### **ADDENDUM #3**

#### **Rye City School District**

***Issued: 2021-02-11***

**This Addendum No. 3 forms part of the Contract Documents and modifies the original bidding documents dated, January 19, 2021.**

2 Kiva Plan

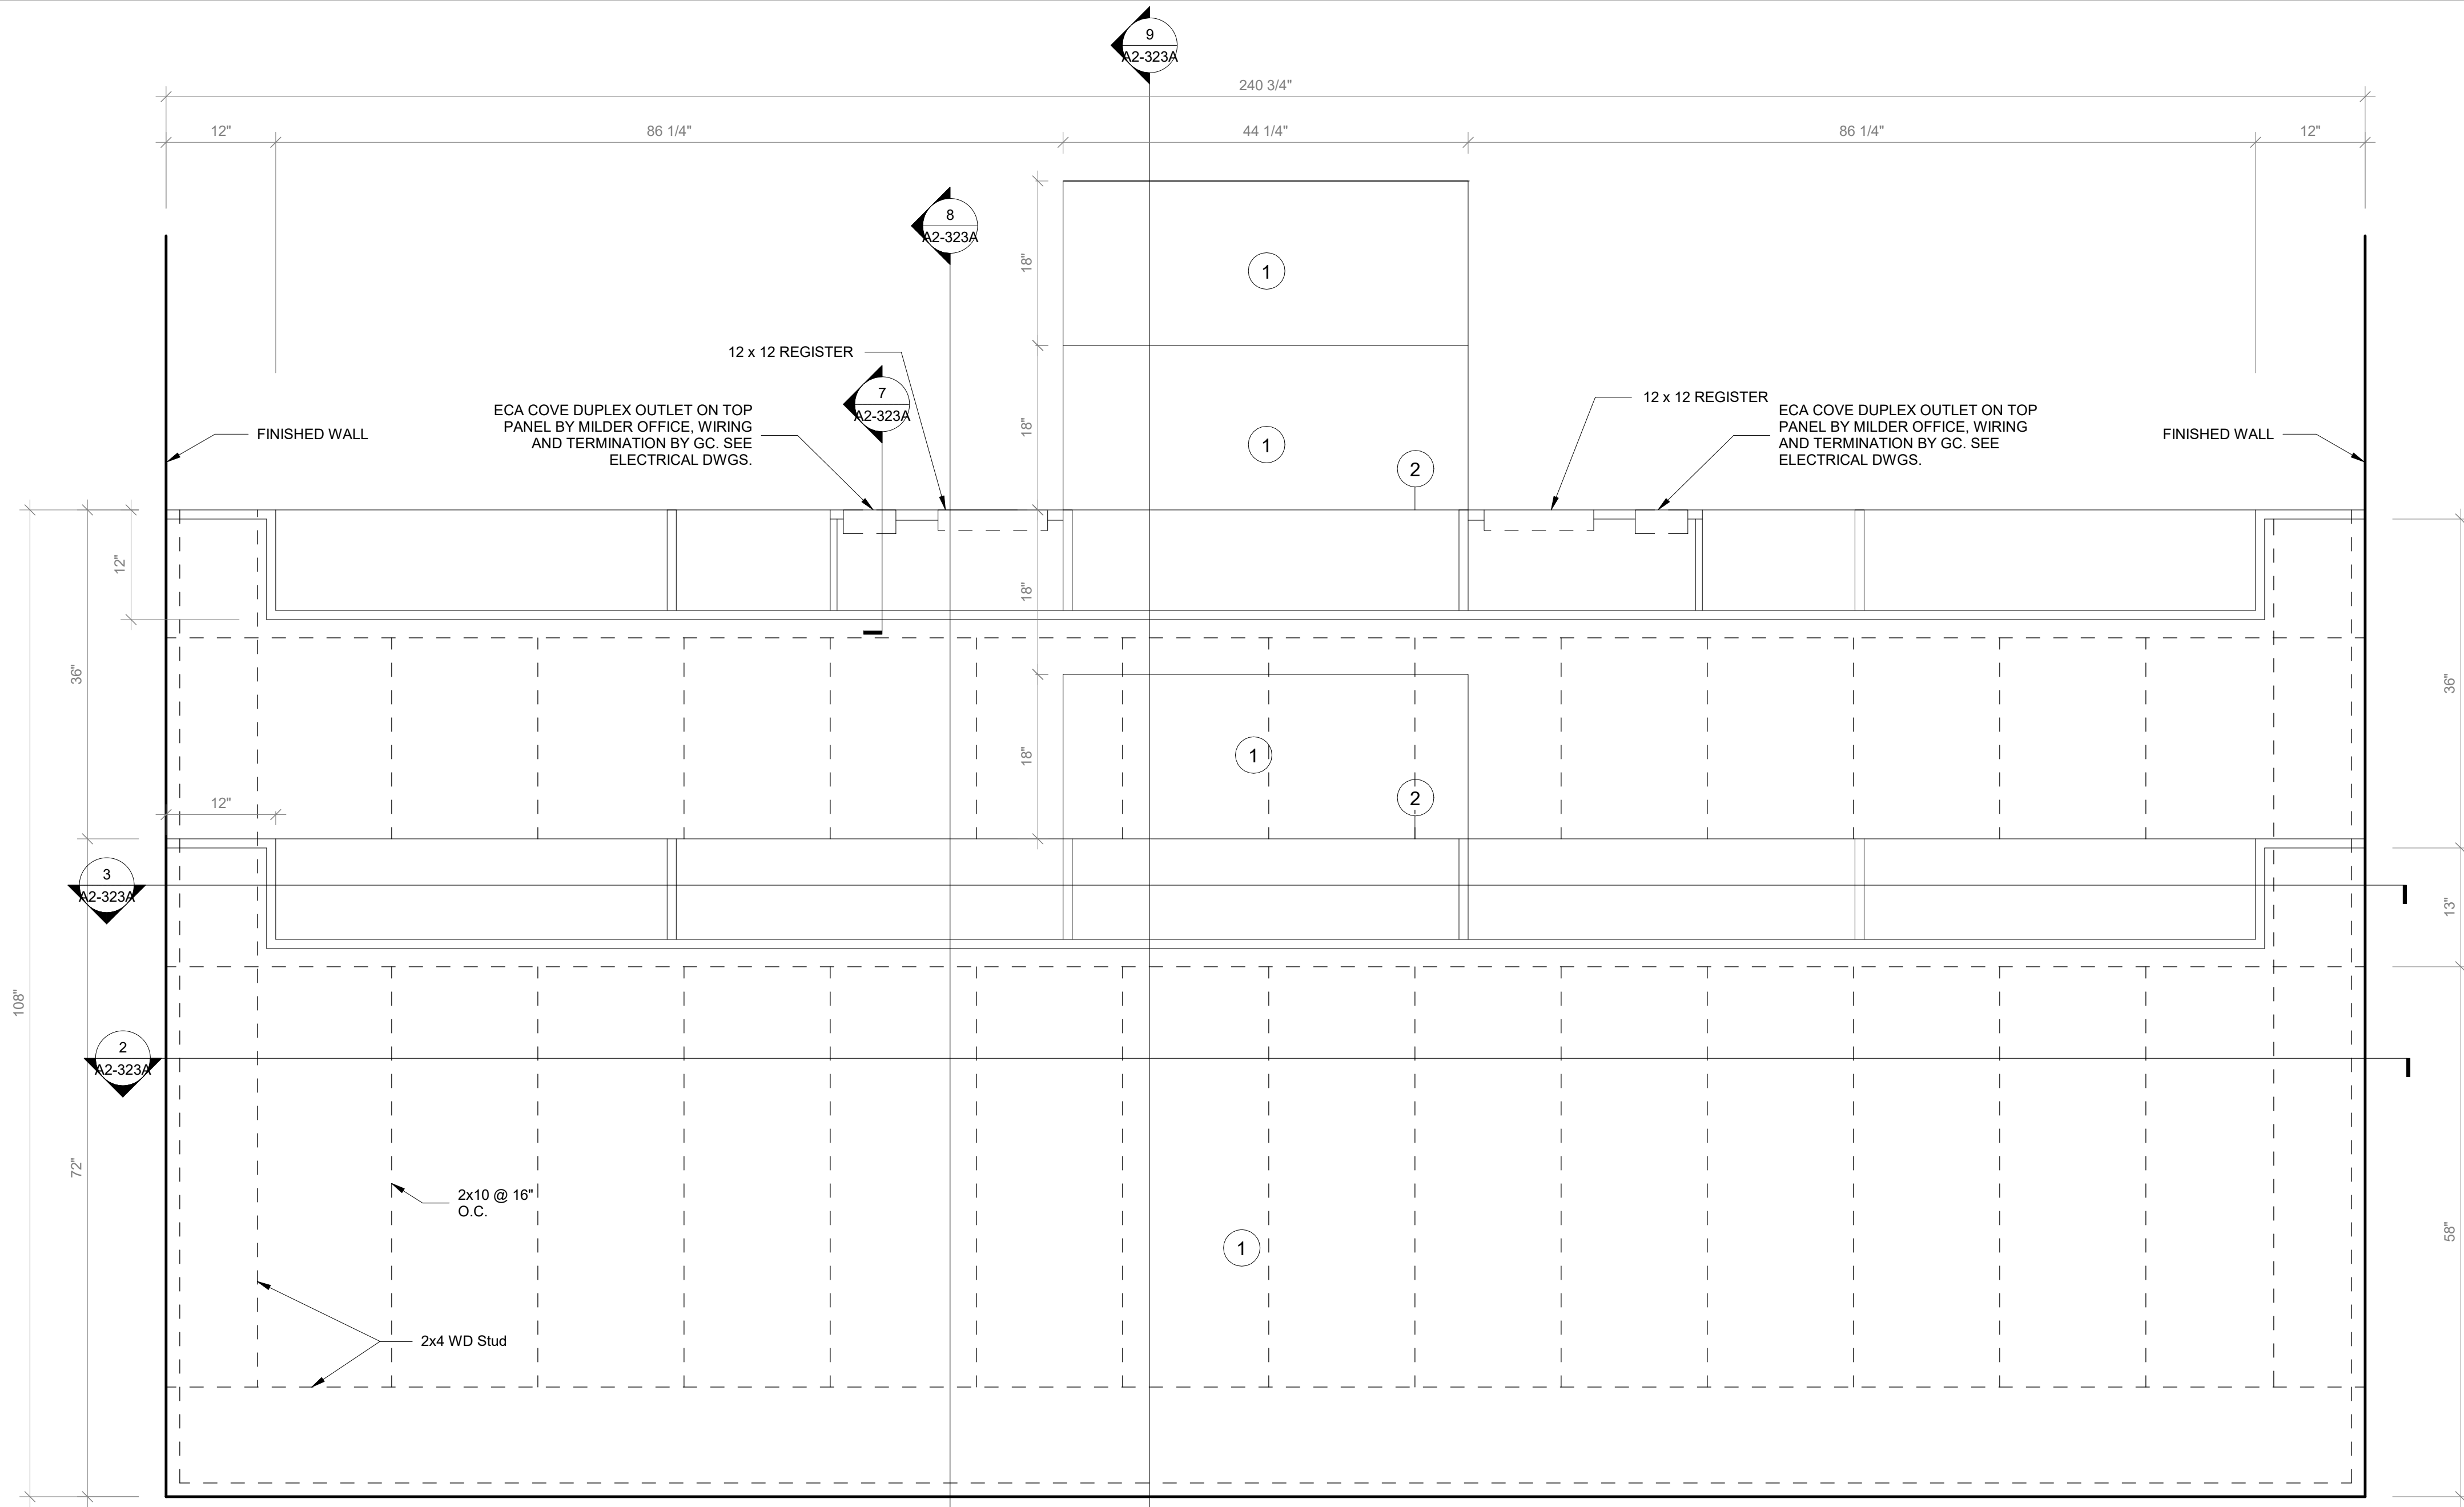
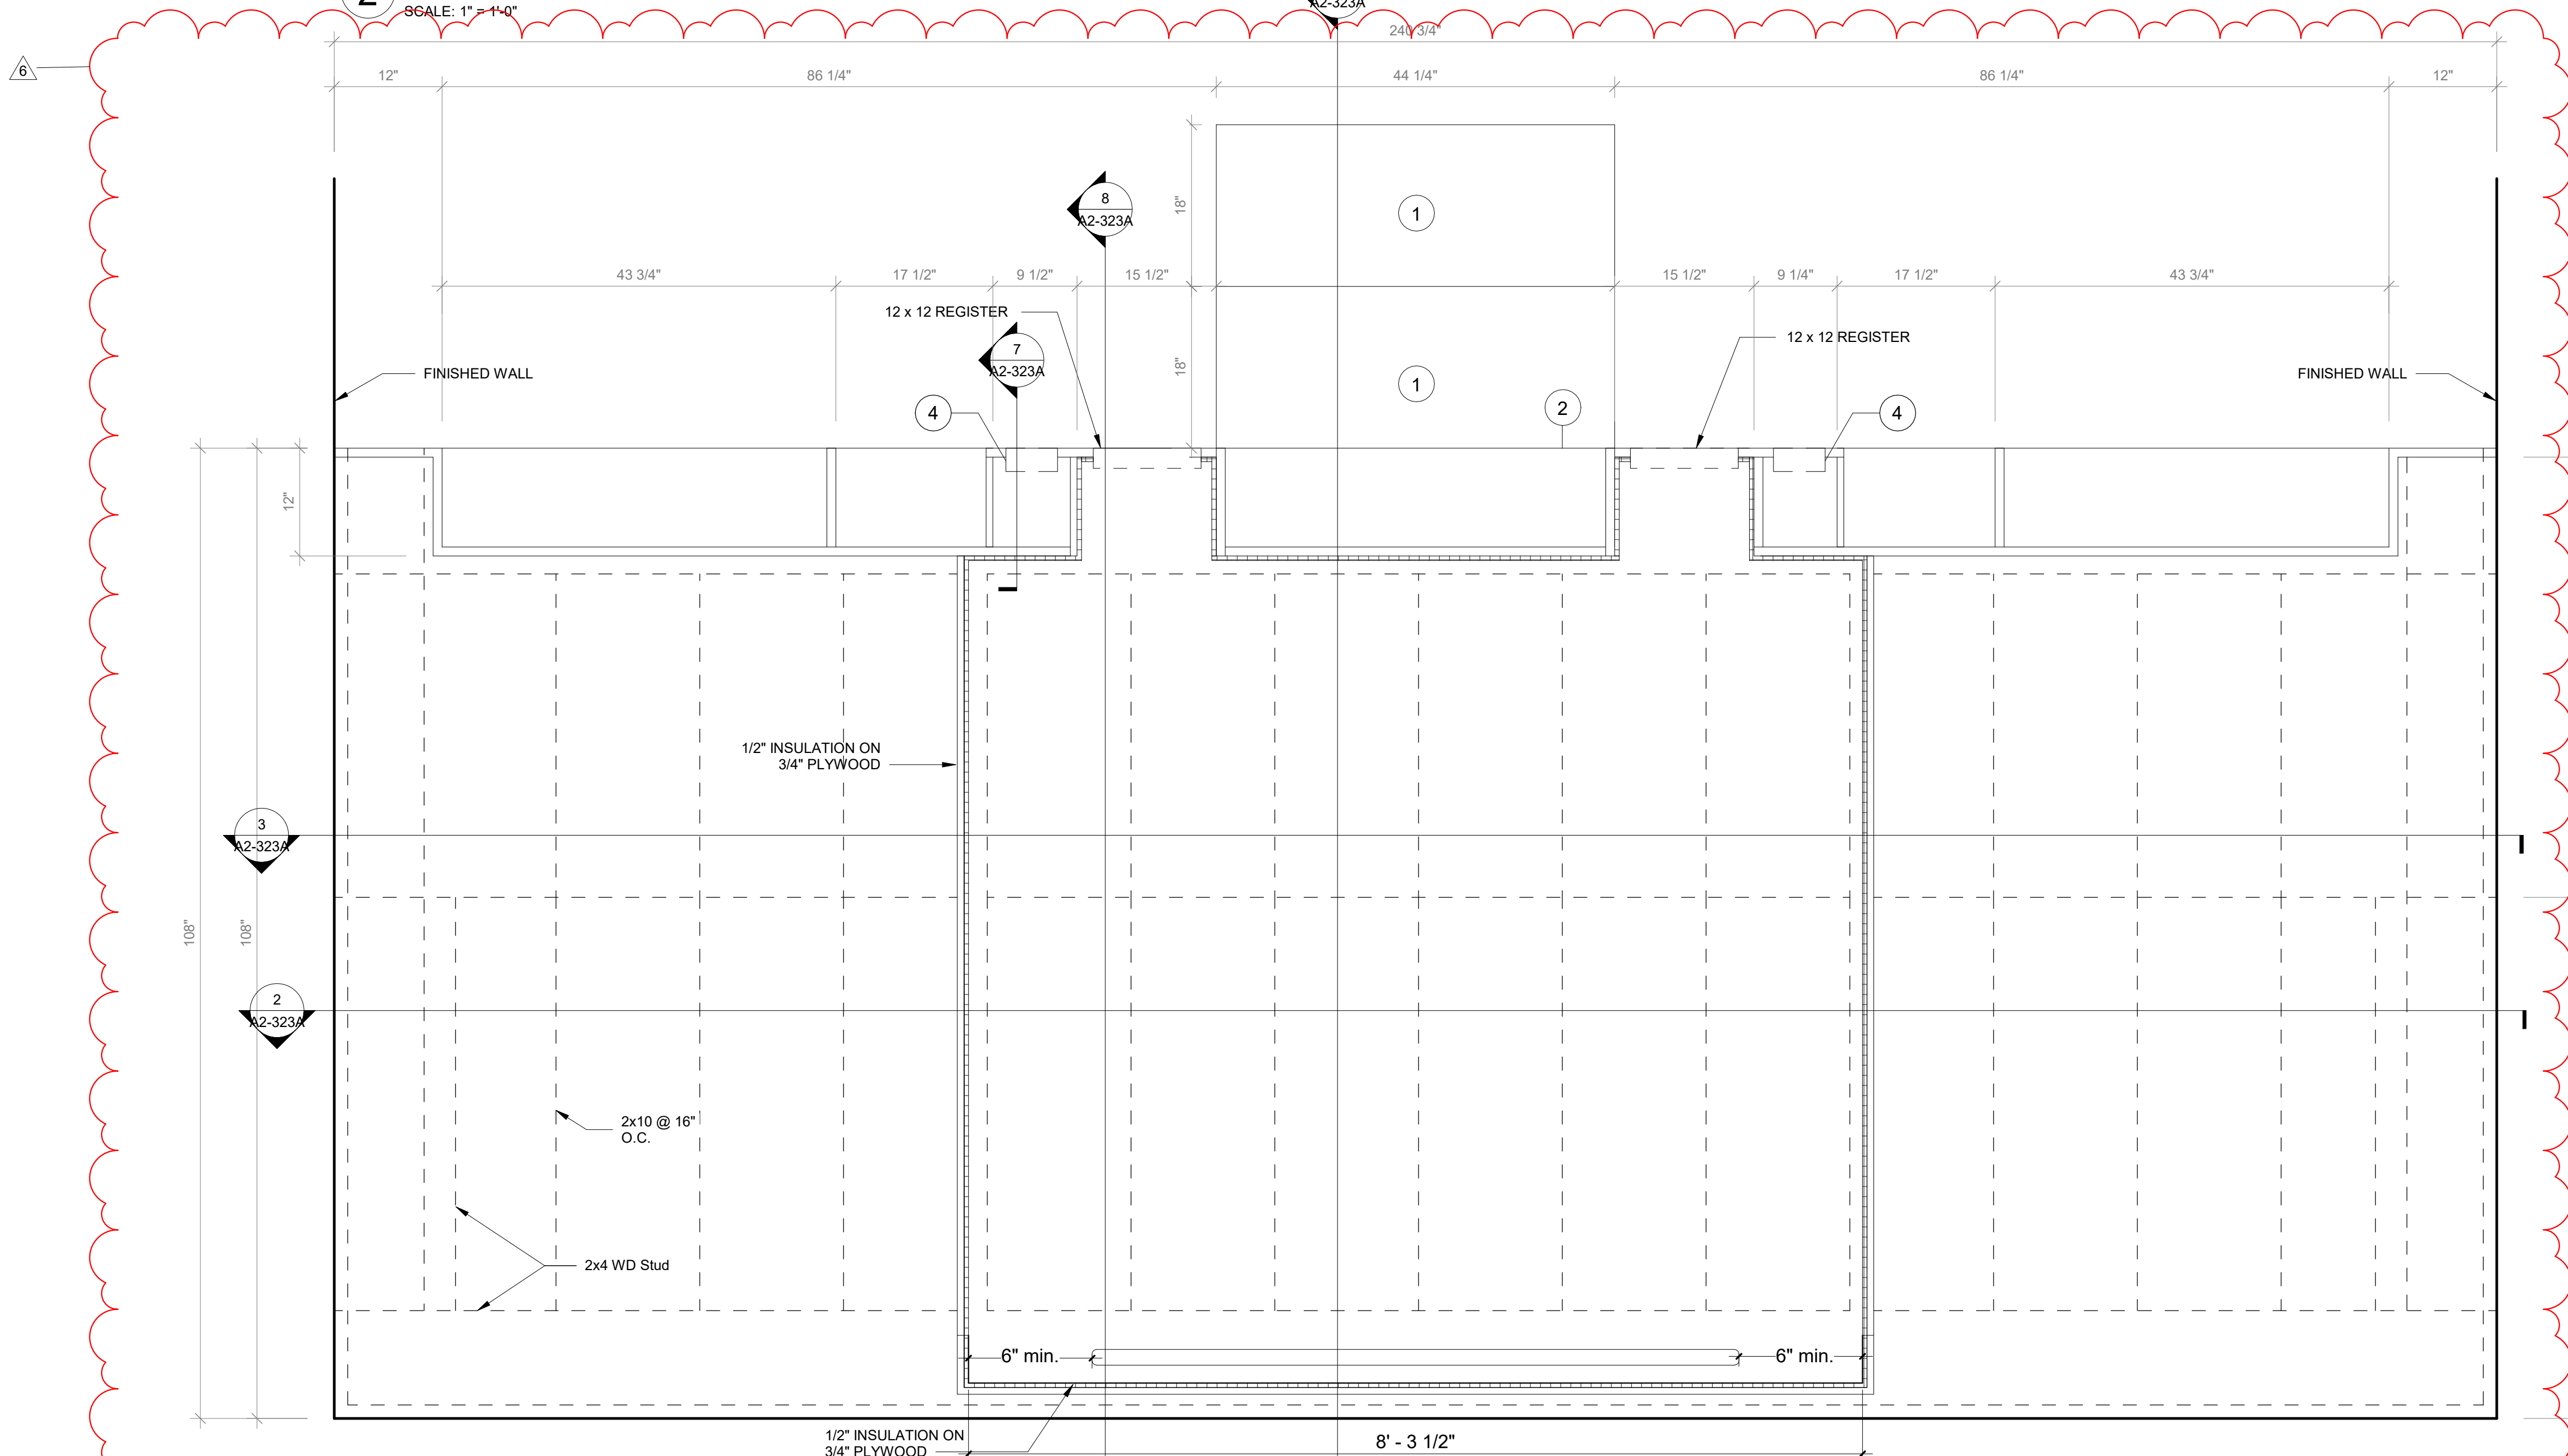
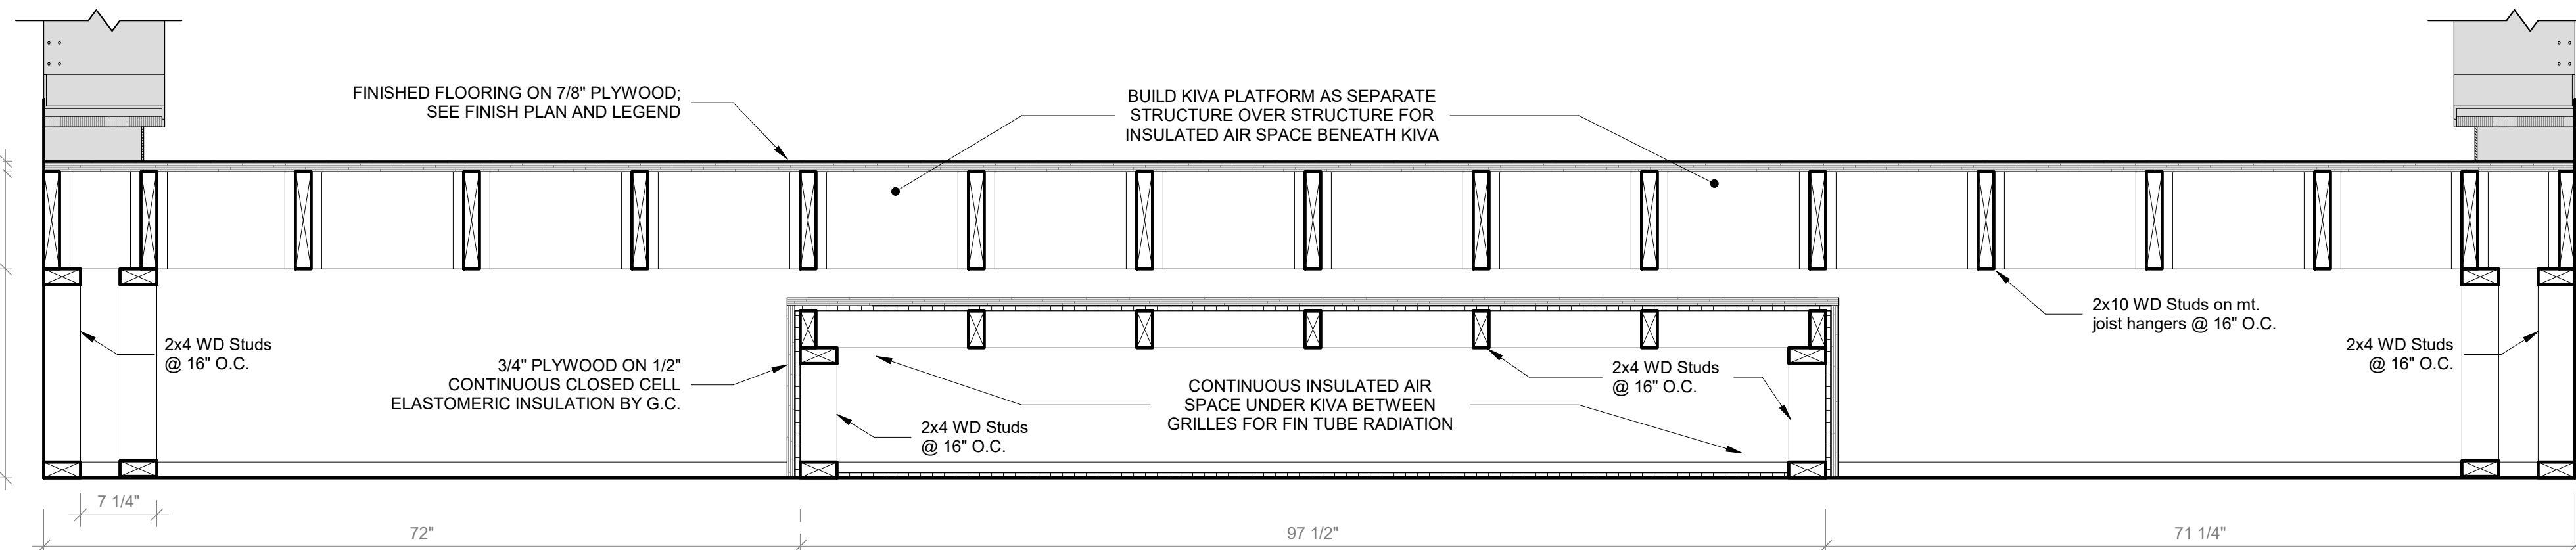
- a. Detail 5 eliminated, as it is redundant. Kiva Section C revised. Kiva Section D and Kiva Section E added for clarification. Sheet re-arranged and re-numbered.
